MEETING ON RECALCULATION OF  
SEISMIC RESPONSE SPECTRA:  
COMANCHE PEAK

Location: Bethesda, Maryland  
Date: Tuesday, June 18, 1985

3  
4 MEETING ON RECALCULATION OF SEISMIC RESPONSE SPECTRA:  
5 COMANCHE PEAK

AUXILIARY BUILDING  
FLOOR RESPONSE SPECTRA  
FSAR vs RSI RE-ANALYSIS

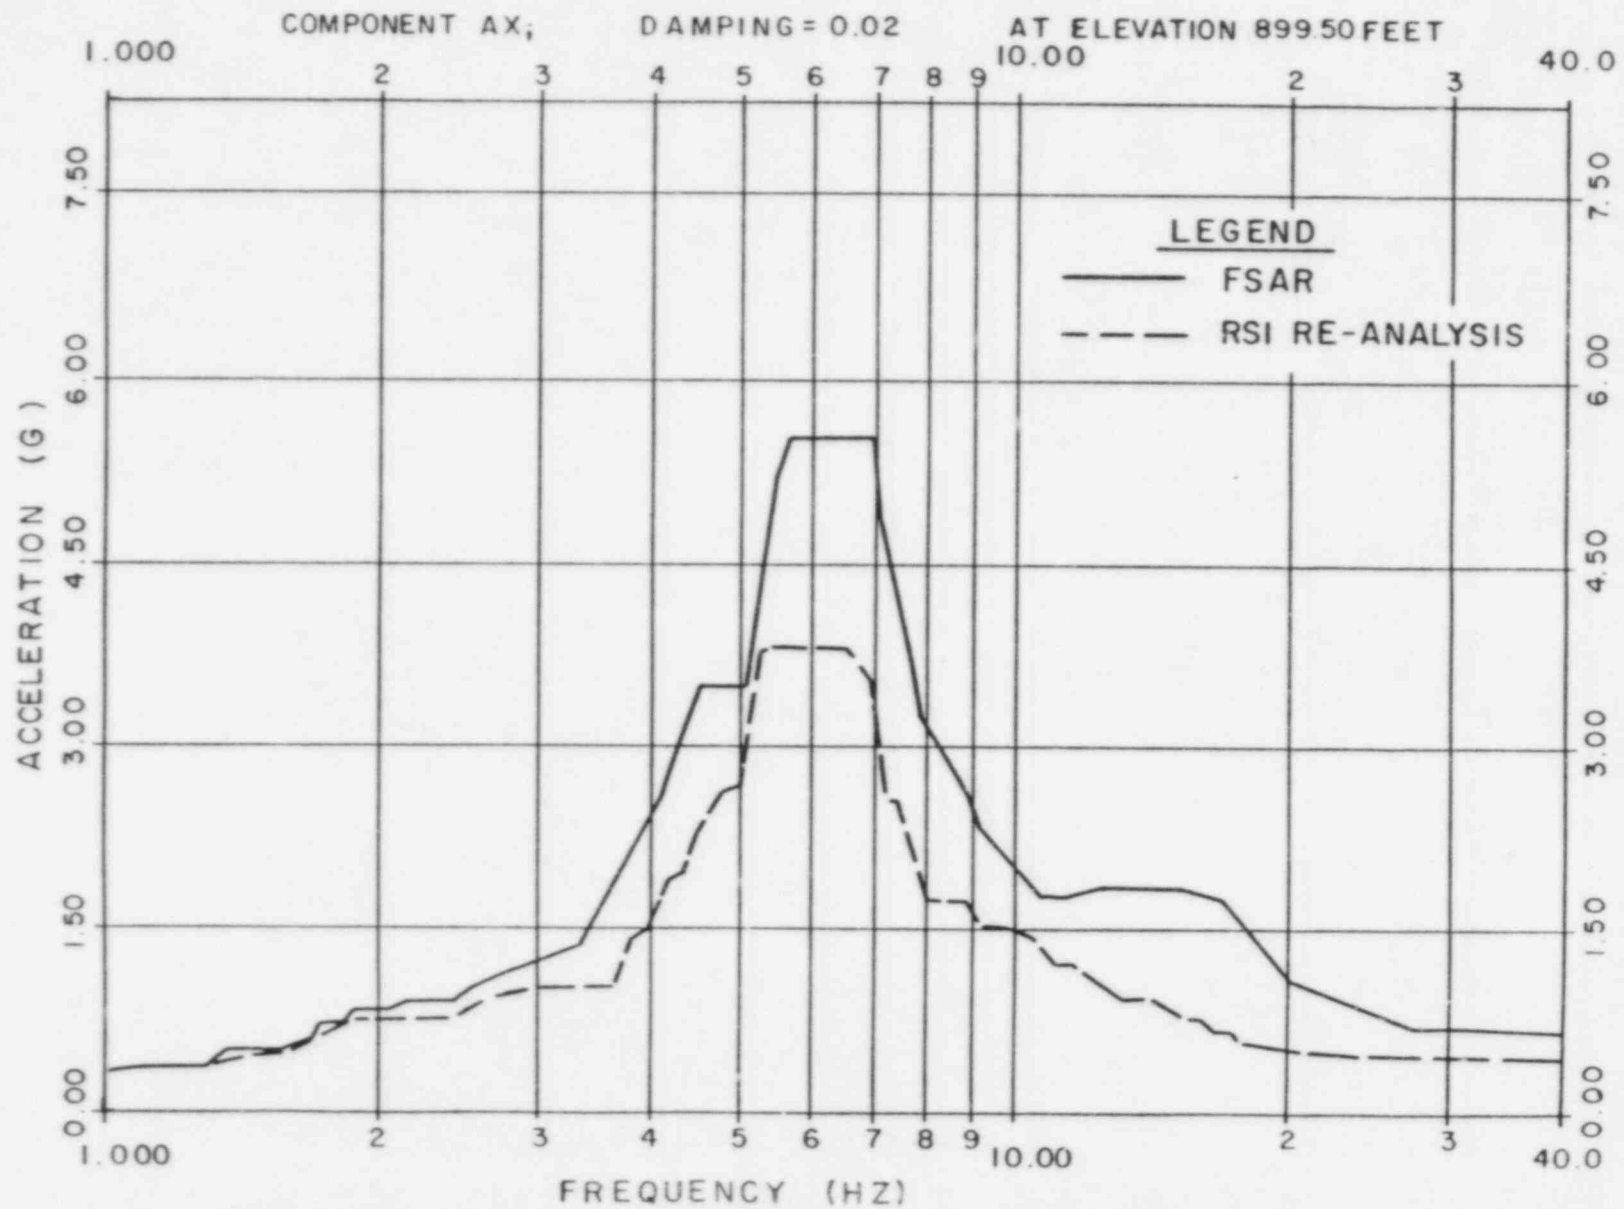
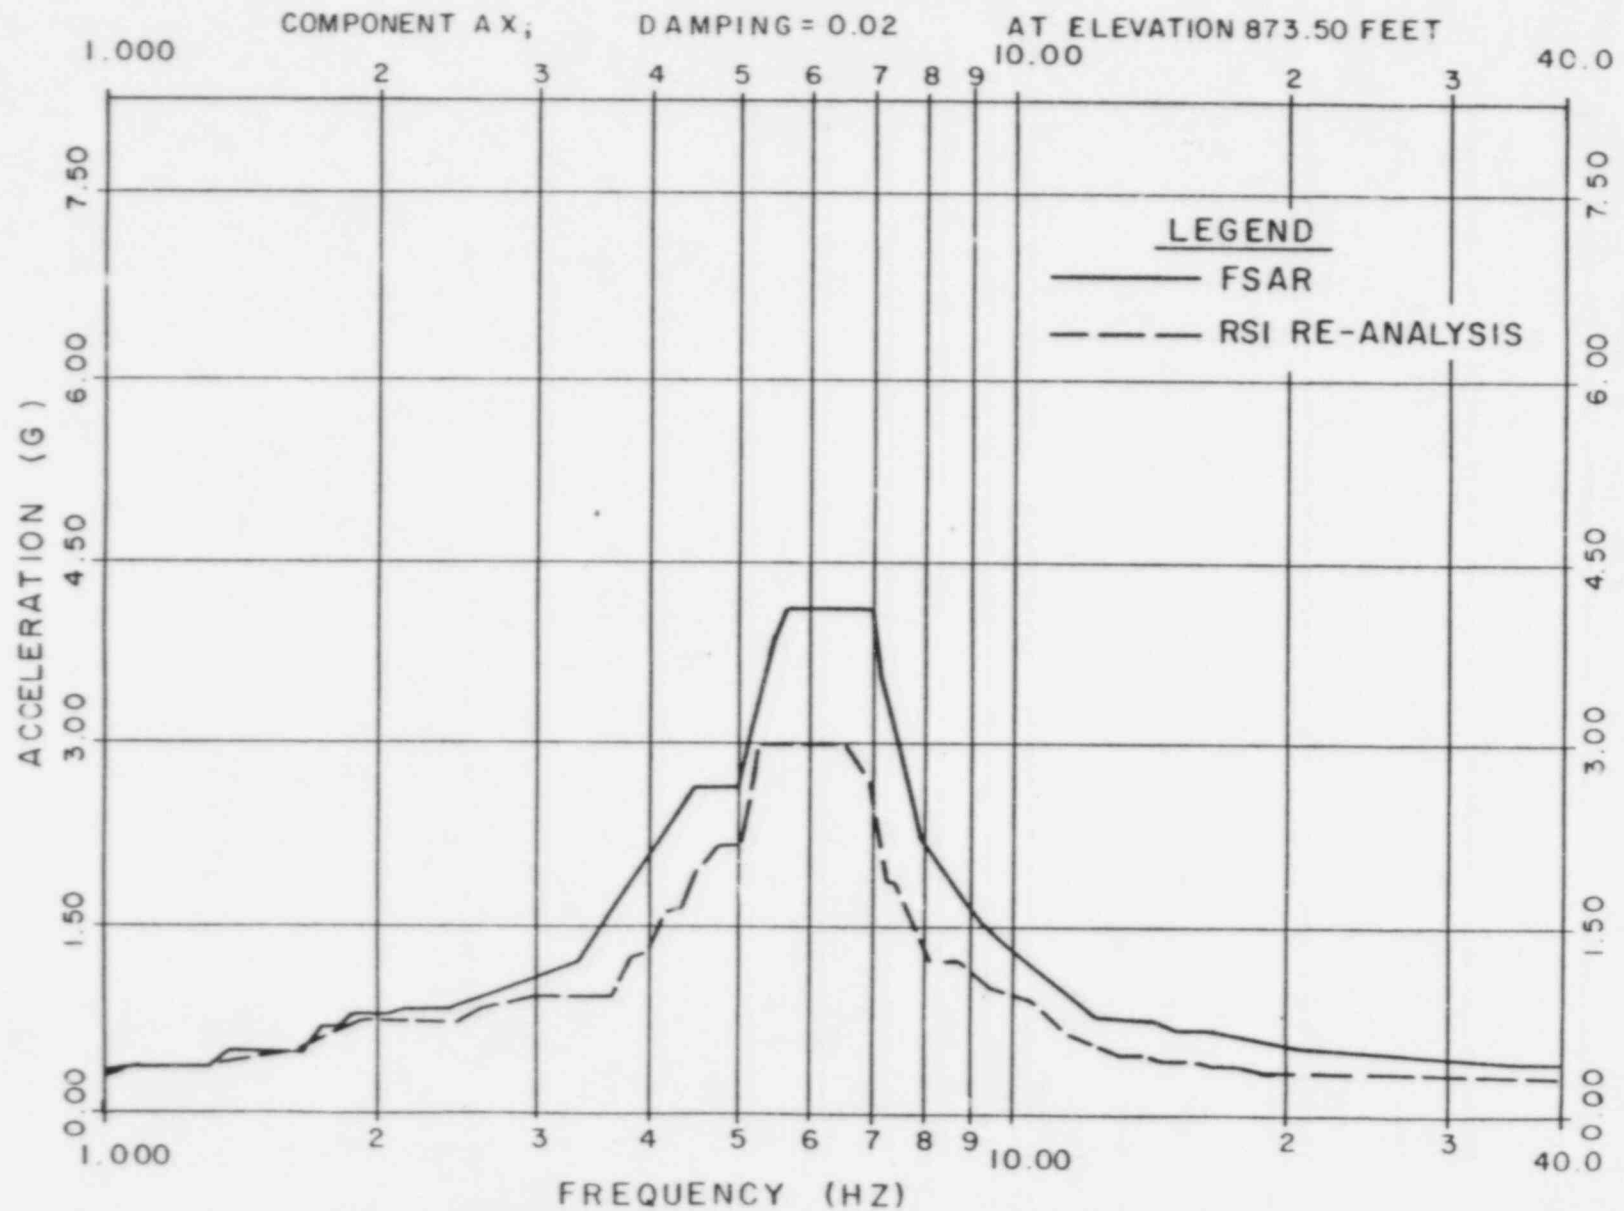
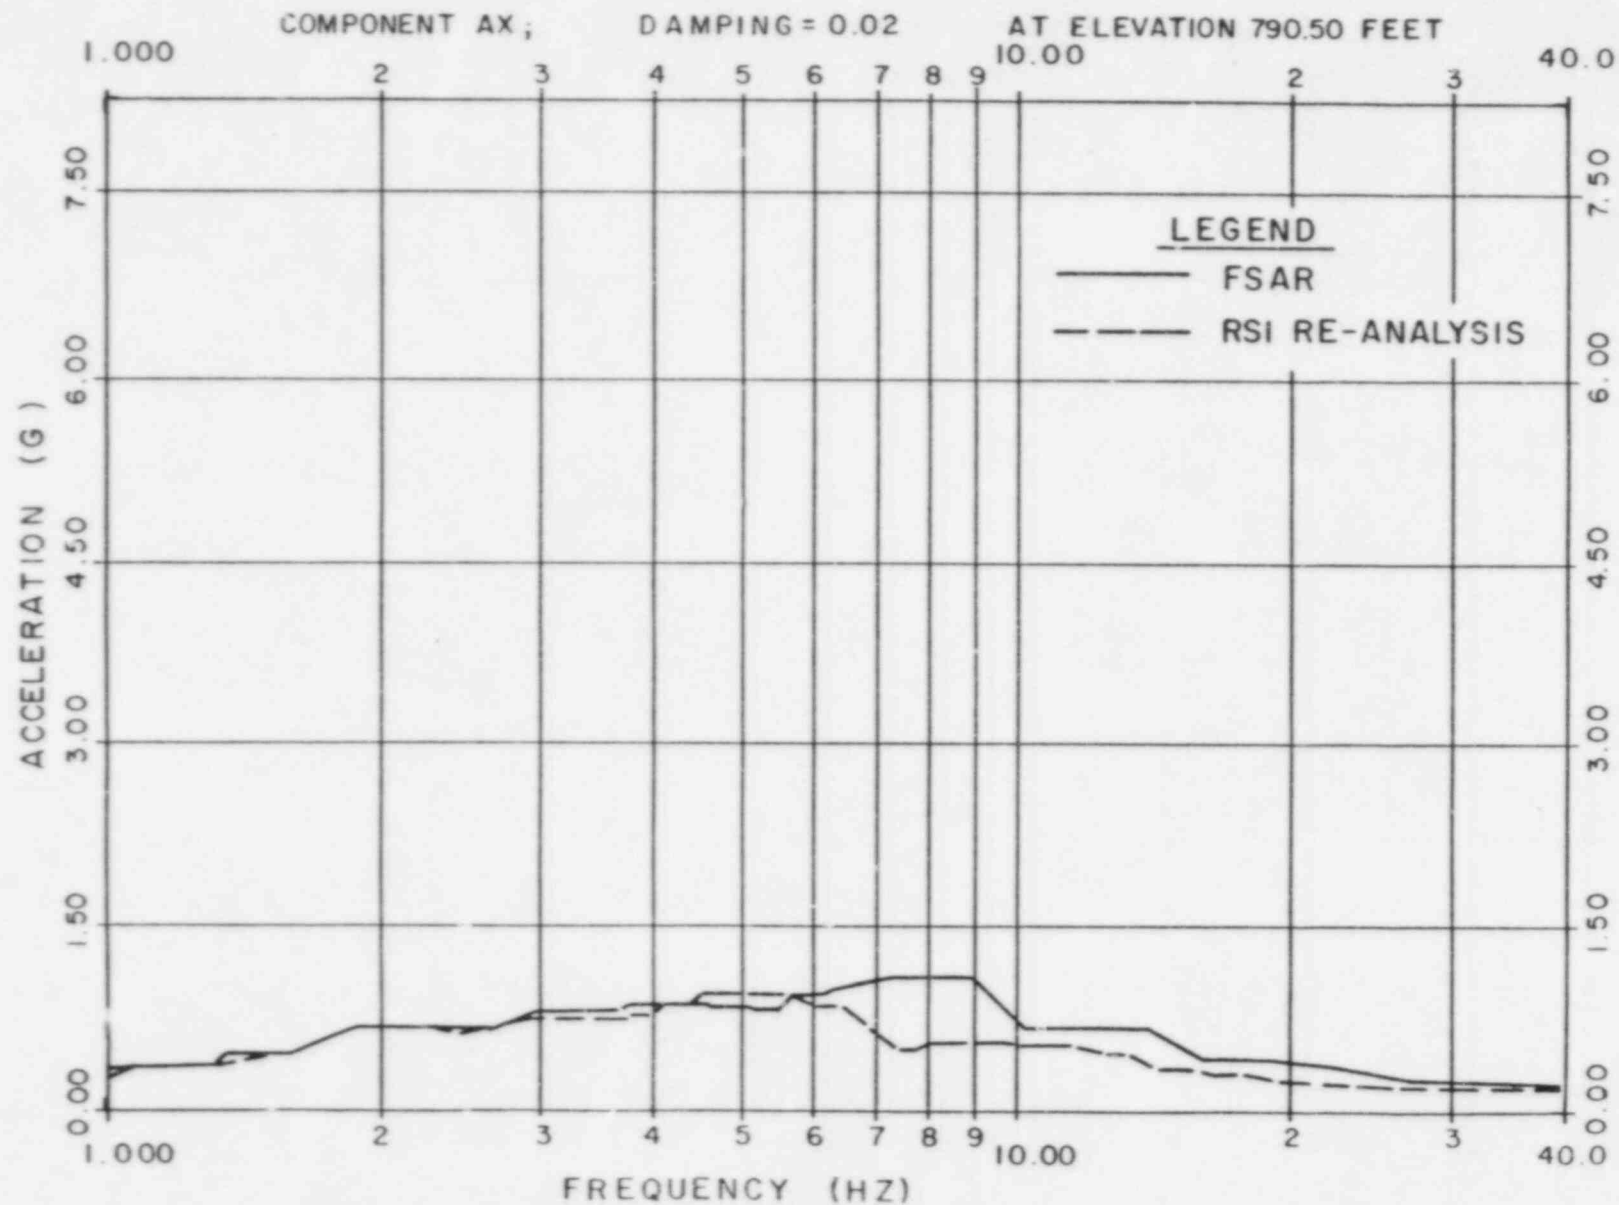
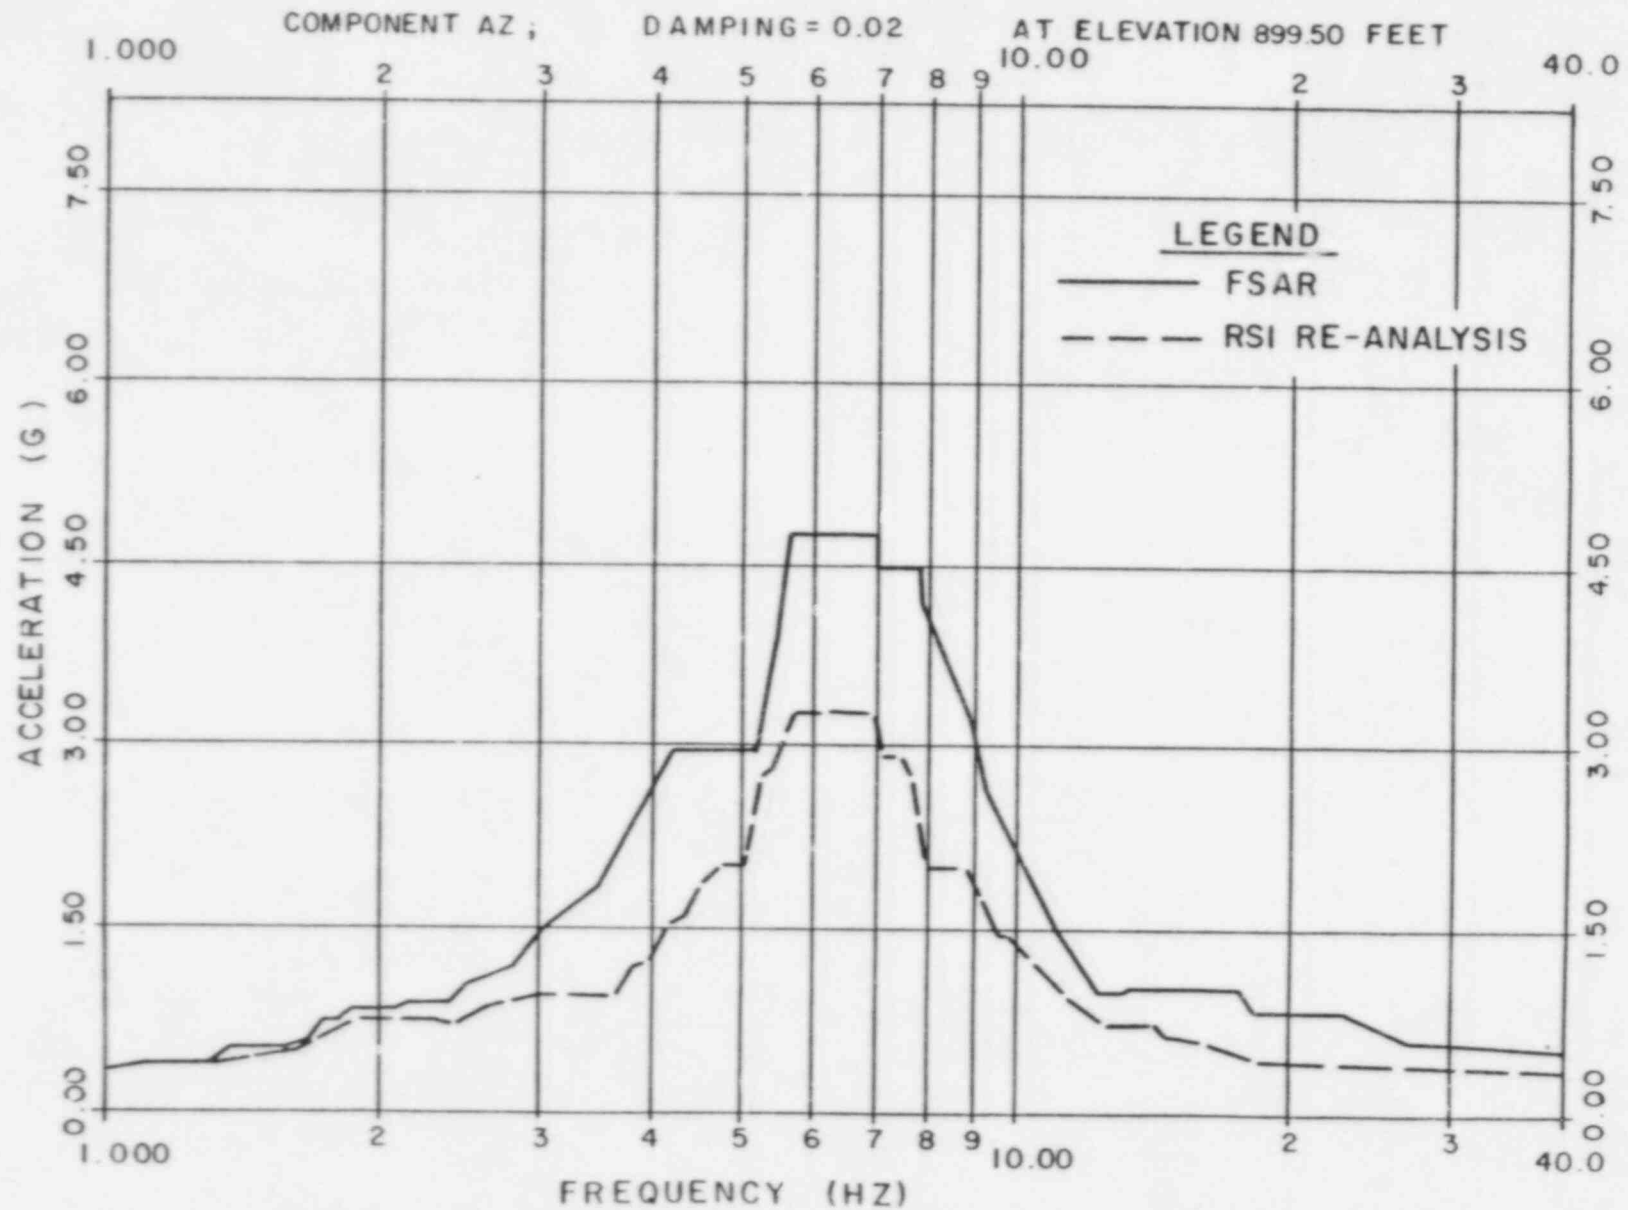
4 MR. JENG: How about the effect that you are finding  
5 the rocking and torsion increase by ten times? Would that be  
6 a major contributor in the reduction of the upper level  
7 response?

16 MR. RINALDI: I have two short questions. One, you  
17 refer to peak broadening. You use plus and minus 10 percent.  
18 I want to caution you that the new requirement is 15 percent  
19 unless you can prove otherwise. Just a comment.

20 The other thing is a question basically on the  
21 spectra you showed for 2 percent damping. Can you comment on  
22 5 percent damping? Is there significant change from what you  
23 show?

18 MR. CLOUD: On the issue of the peak broadening, I  
19 guess we have felt that the Standard Review Plan was slightly  
20 different than you stated it. We felt that it called for 15  
21 percent, but that 10 percent would be acceptable, provided it  
22 was justified with additional studies.

2               In our view, that satisfies this approach  
3       (indicating). Any reasonable method for determining the  
4       amount of peak widening, and we add 10 percent on top of  
5       that. It says "plus or minus." We take 10 percent on top of  
6       the widening.
